ANNEX A

MEDWAY GAP CHARACTER AREA APPRAISAL SPD - RESPONSE TO CONSULTATION

L11 –MILLHALL

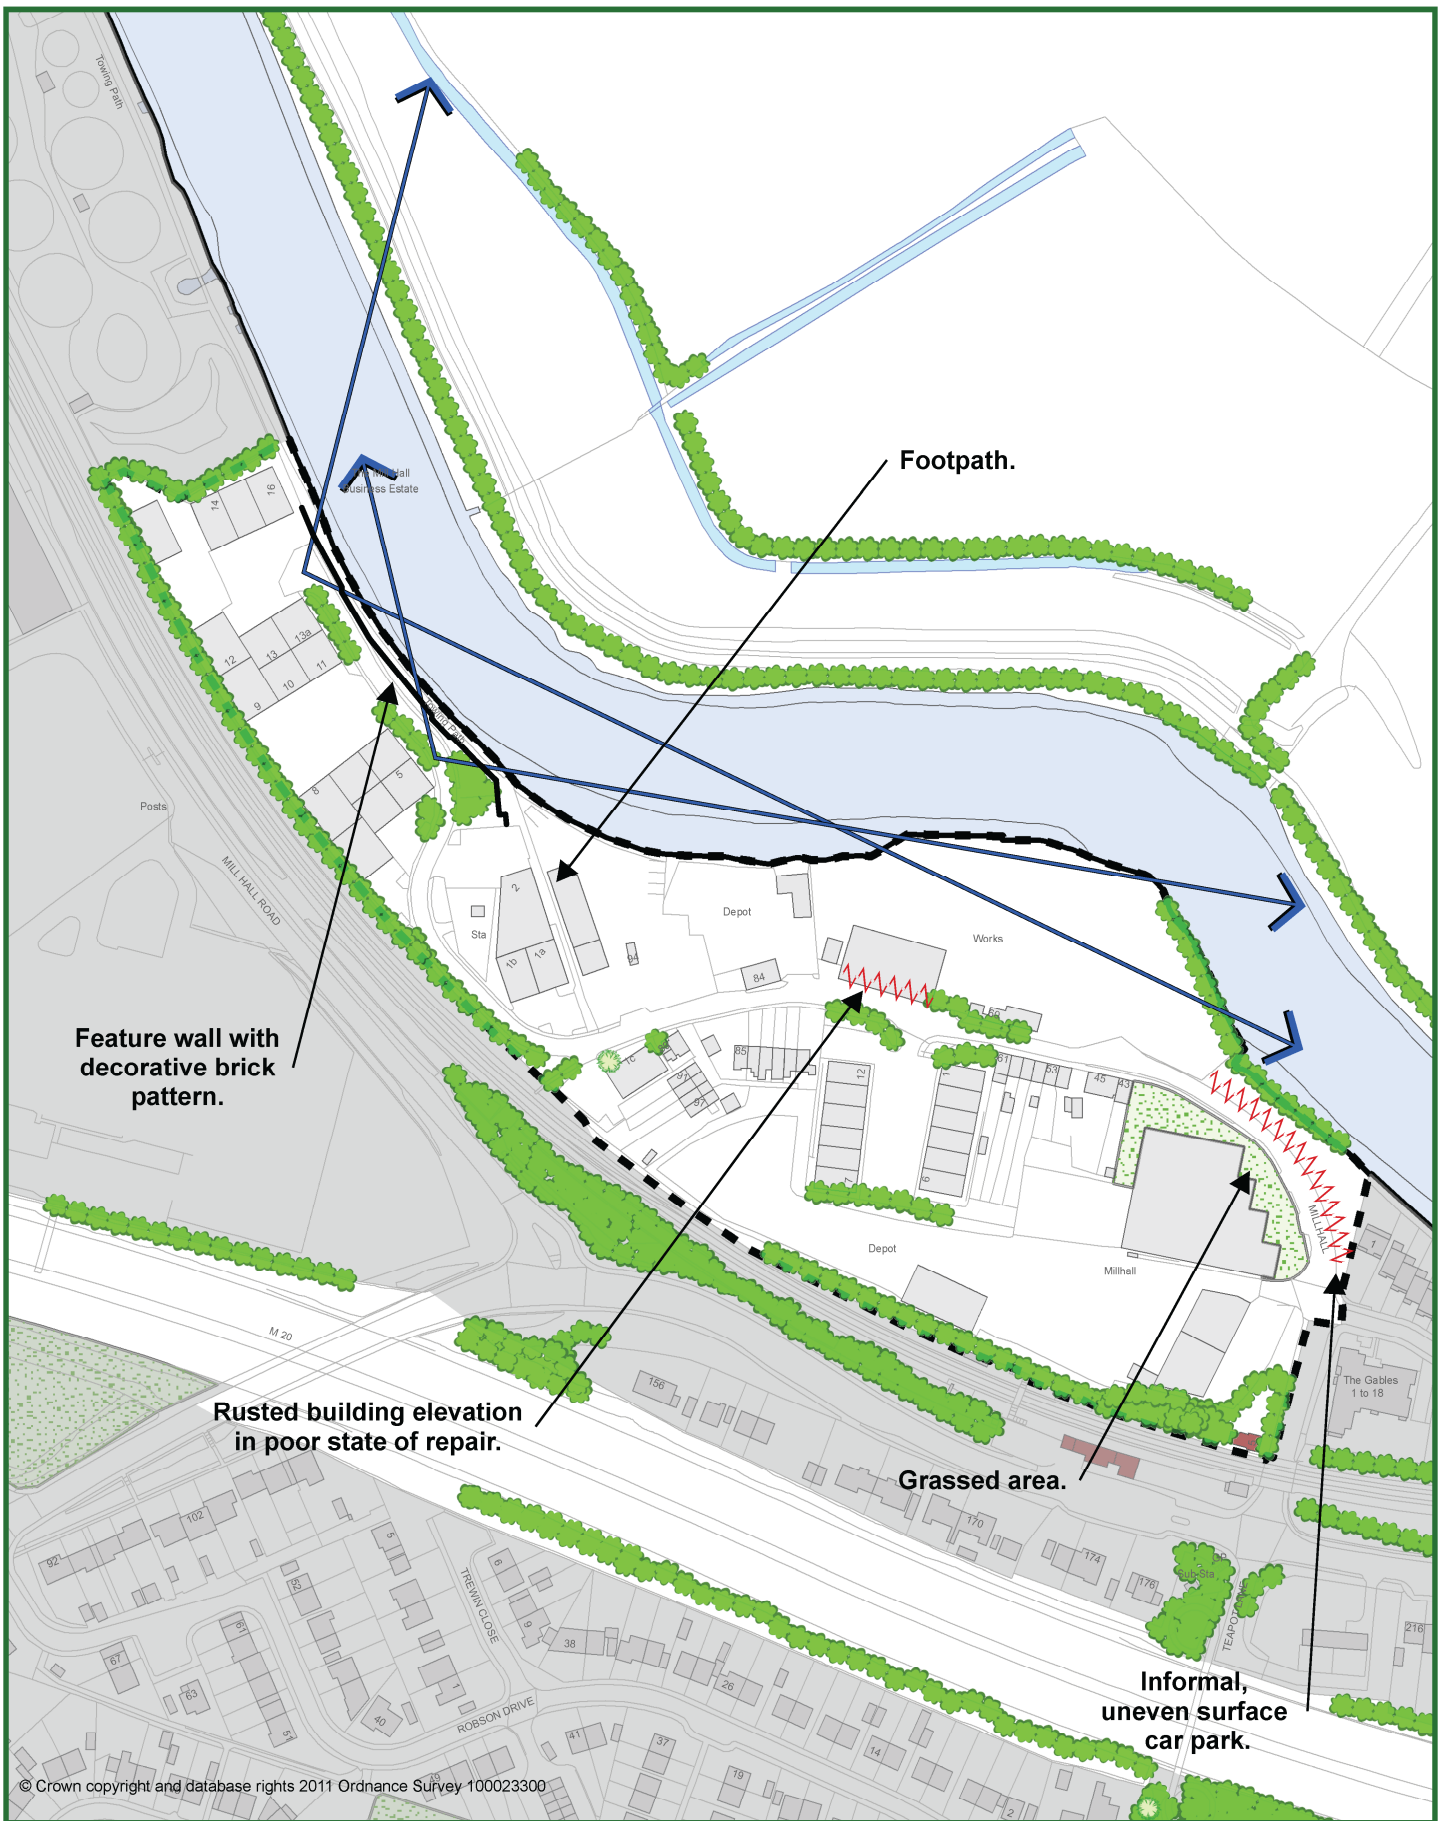
Respondent	Representation	Response
Mr J Brooks	The residential properties in Mill Hall are included as part of the industrial area. They should be part of their own character area.	Agree. ADD NEW CHARACTER AREA FOR MILL HALL (See Appendix A1)
